Submissions Report

MIXED-USE DEVELOPMENT WITH IN-FILL AFFORDABLE HOUSING AT 241-245 PENNANT HILLS ROAD, CARLINGFORD

(SSD-84699461)

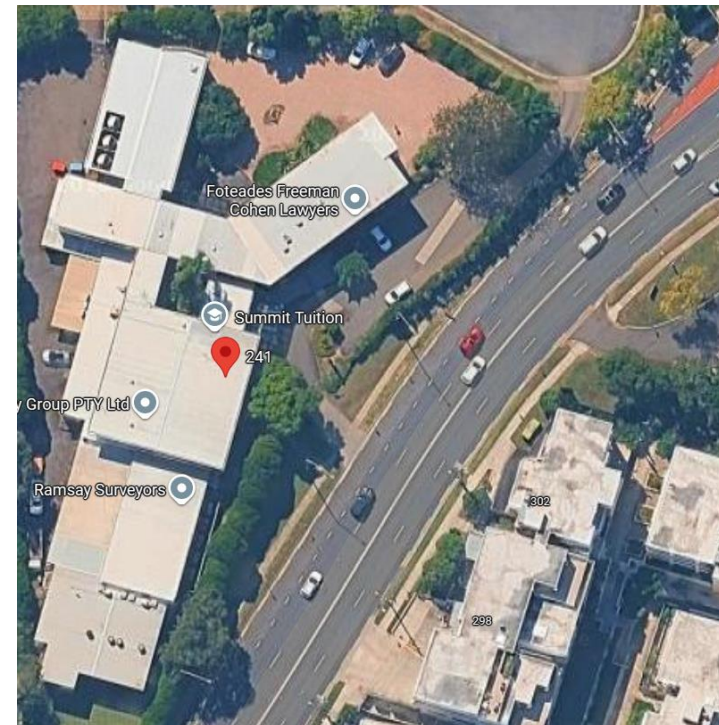
A 10-metre front setback is required along Pennant Hills Road, which is being applied consistently to recent development proposals on this corridor including large mixed-use schemes such as the site further to the north (263-281 Pennant Hills Road, Carlingford). This setback must be measured from the future property boundary, accounting for the land that will be acquired as part of the TfNSW road widening program. When the ultimate boundary is considered, the current scheme positions the building too close to the street, and the footprint will need to be adjusted to achieve the required setback.

Retaining only 6 m at the primary frontage limits the ability to establish a robust landscape buffer, constrains opportunities for large canopy trees, and results in an excessive built interface with the major arterial road. In addition, the reduced setback reduces the amenity and usability of balconies facing Pennant Hills Road due to excessive noise emissions and pollutants.

A setback of 10 m would provide space for taller tree species, improve pedestrian amenity, and help moderate the scale and visual impact of the podium and tower when viewed from Pennant Hills Road. Large street trees, able to grow to a height of more than 15m, should be Page 4 of 17 planted at 10-12m centres within the front setback to provide a green edge.
